POSITION PAPER Version 4.0

Revision of the Technical Specification for Interoperability / Safety in Railway Tunnels (SRT)

Brussels, September 26th, 2012

IU-SRT_TSI

Figure 1: <http://www.bahnonline.ch/wp/34318/brand-gueterzug-simplontunnel-brig-iselle-di-trasquera.htm>. Date: 10.11.2011

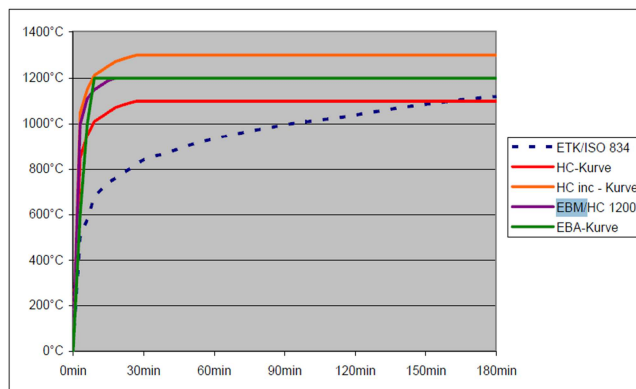
- *The stipulated EUREKA - curve can be used for tunnels for passenger traffic only. Freight traffic demands different types of curves. Durations of fires in tunnels for mixed (passenger AND freight traffic) traffic or freight traffic only were observed up to several hours in the past years (e.g. Simplon Tunnel 12 hours). A cooling down phase after 60min in the EUREKA curve is not a realistic input for structural analysis.*
- *Therefore fire loads should/shall be derived from open curves such as the HC₁₂₀₀ curve. For material tests a temperature-range between HC and the HC_{inc} may be proposed.*
